County of Placer

SUBJECT: GENERAL PLUMBING SUPPLY SIGN PERMIT

APPLICANT APPEAL OF THE PLANNING DIRECTOR'S DENIAL OF A SIGN PERMIT

(PLN20-00134)

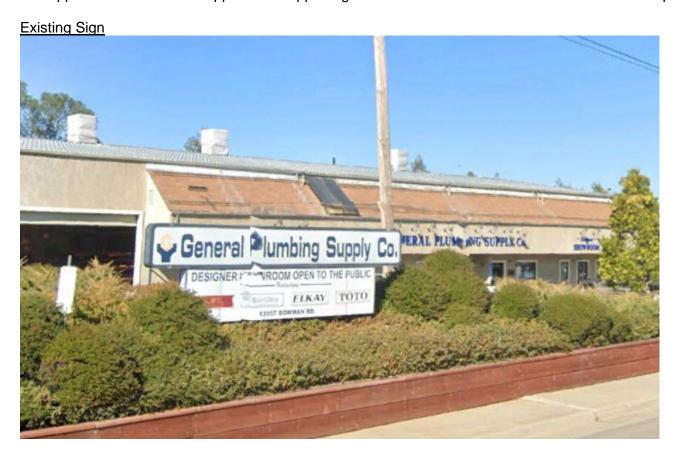
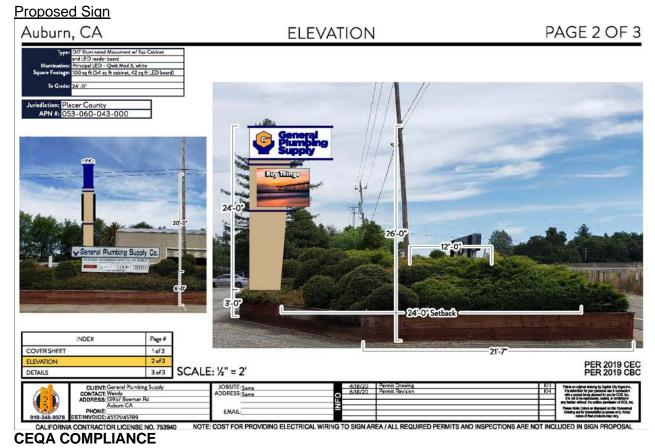
The specific issue of contention was the proposed full-color (LED) animated display changeable copy reader board sign. The appellant contends that Placer County Code does allow LED signs if the changing advertisement cycle rates exceed three seconds. Placer County Code, Chapter 17, Article 17.54, Section 17.54.170, subsection (D)(2) states:

The specific issue that resulted in the initial incomplete determination was the proposed 5'-6" tall by 7'-10" wide (42 square foot) full-color light-emitting diode (LED) digital display changeable copy reader board sign. In the incomplete application letter staff requested the LED sign component be removed from the proposed sign for the following reasons:

- Proposed sign is not compatible with the rural character of the surrounding Bowman area community;
- Type of sign proposed is discouraged in the County's Sign Design Guidelines; and
- Animated signs are prohibited pursuant to subsection 17.54.170(D)(2) of the Placer County Code.

As provided in the analysis above, it is the determination of the Planning Director that Section 17.54.170(F), which prohibits intermittent lights (changeable copy), with the exception of time and temperature displays, is more restrictive than Section 17.54.170(D)(2) which also allows for electronic changeable copy signs with cycle rates longer than three seconds and traditional barber poles.

Therefore, pursuant to Section 17.02.050(D)(1), it is the determination of the Planning Director that LED changeable copy signs, other than for time and temperature displays, and regardless of the length of time of the cycle rate, are determined to be inconsistent with the Zoning Ordinance.

Staff requests that the applicant revise the proposed sign exhibits and remove the LED display component.
